SUBJECT: Forwards revision to Question 40.6 re degraded grid voltage, closing SER Outstanding Issue 49.

SUSQUEHANNA STEAM ELECTRIC STATION  
SER OUTSTANDING ISSUE 49  
ER 100450 FILE 841-2  
PLA-781

QUESTION 040.6

FIGURE 8.3-16

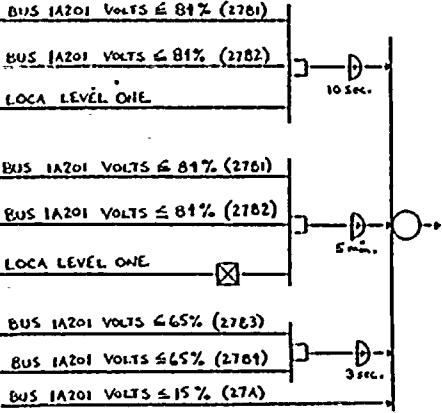
If a degraded voltage condition occurs on the 4.16 kV Class 1E bus, with no LOCA signal present (see Figure 8.3-15), which is below the setting of relays 27B1 and 27B2, an alarm (coincidence logic) will be initiated after 10 seconds. The relays will initiate the bus transfer after a 5 minute time delay during non-LOCA conditions. A LOCA signal bypasses the 5 minute time delay. The 10 second time delay is provided to preclude spurious alarms and trips for motor start transients. The

In the event of loss of voltage on the 4.16 kV Class-1E bus, the bus undervoltage relay (27A) initiates bus transfer per paragraph (b) above. In addition, relays 27B1, 27B2, 27B3, and 27B4 provide back up protection for alarms and initiating bus transfer.

5 minute timer is provided for operators to initiate corrective actions during non-LOCA conditions. Relays 27B1 and 27B2 initiate an alarm when the diesel generator is supplying power but do not trip the diesel generator breaker.

In addition, relays 27B3 and 27B4 trip the offsite supply breakers after a time delay of 3 seconds when the bus voltage falls below their setting. These two relays are also connected in a coincident logic. Their setting is based on coordination with overcurrent relays to prevent false trips due to transient voltage dips from fault currents. These relays have no function when the diesel generator is supplying bus power.
